DOCUMENT DESCRIPTION: Internal Report

Safety and Health Consultant's Report

5333 Strawberry Lane
Louisville, Kentucky

VS-706

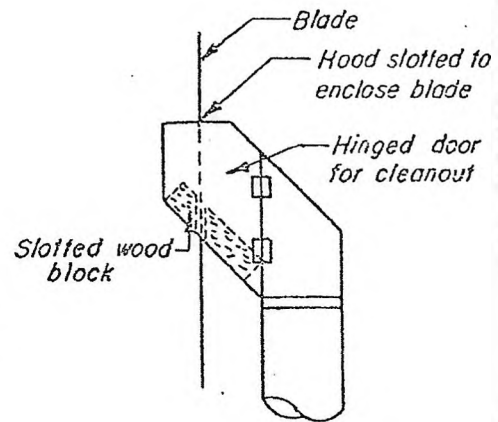
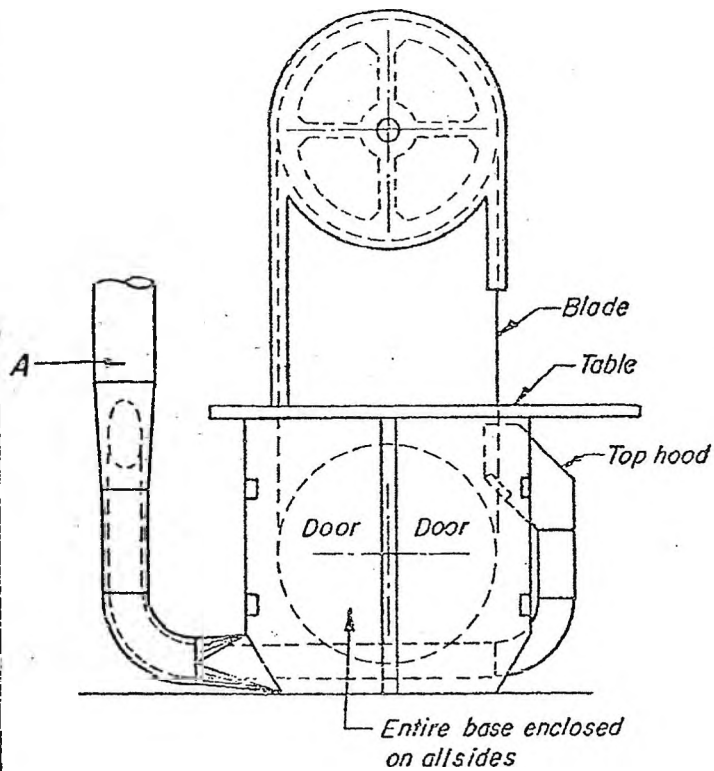
4. The asbestos cutting operation on the LM895 band saw was not being performed during the survey. However, some improvements can be made to increase the ventilation effectiveness.

The open space underneath the table between the table and the slot should be enclosed. By doing so, the hood will be positioned closer to the dust source.

Dust duct velocities of 2,000 to 2,700 feet per minute (fpm) were measured compared to the usual design value of 3,500 fpm. Other design specifications can be found in the enclosed print VS-706 from 'Industrial Ventilation.'

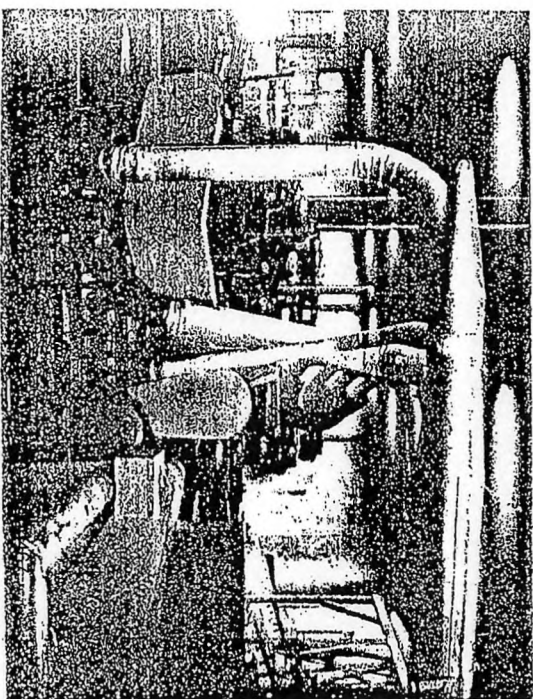
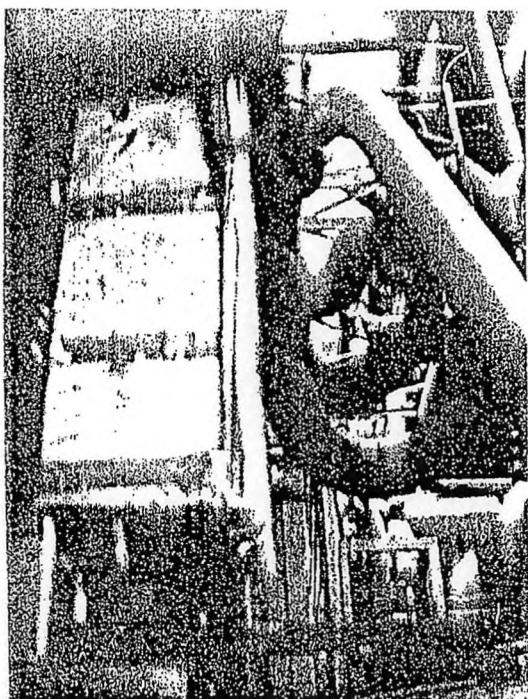
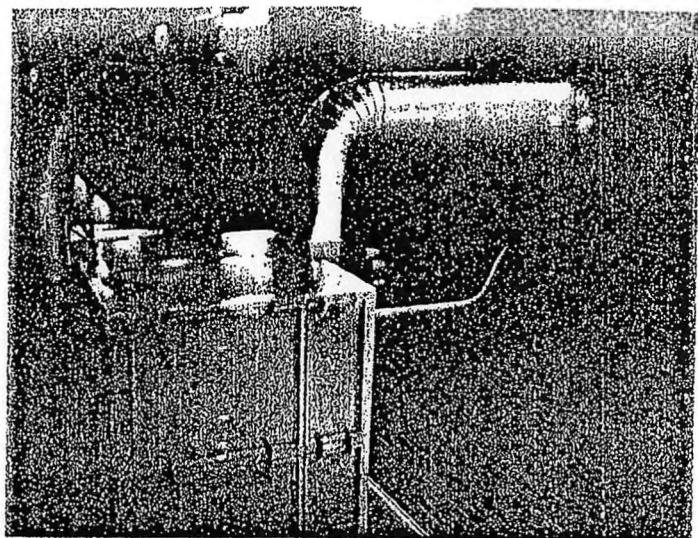
The Armstrong Co. is now advising us that all Asbestos fibers may not be fully encapsulated in the mesoprene in the sheet.

We therefore advise you as follows, per attached Photos

- A. The Honeycomb Machine Saws are now on an American Air Filter "Bag" Unit discharging to the outside air.
- B. The M-67 Machine Saws are now on an "Unknown" brand filter unit discharging into the same room.
- C. Contact AAF in Louisville and have them send out a qualified Sales - Eng to look over the above and recommend how we should proceed to.
 1. Is the M-67 Machine Filter adequate?
 2. Should it be discharged outside the building?
 3. Could both the M-67 & Honeycomb Machine dusts be handled by the present AAF Unit?
 4. Is the present AAF Unit adequate for Asbestos to meet current regulation?
 5. If we add Saws to the SDNA line could we also tie it into this present AAF Unit?
 6. If Not these complete analysis & recommendations with pricing.
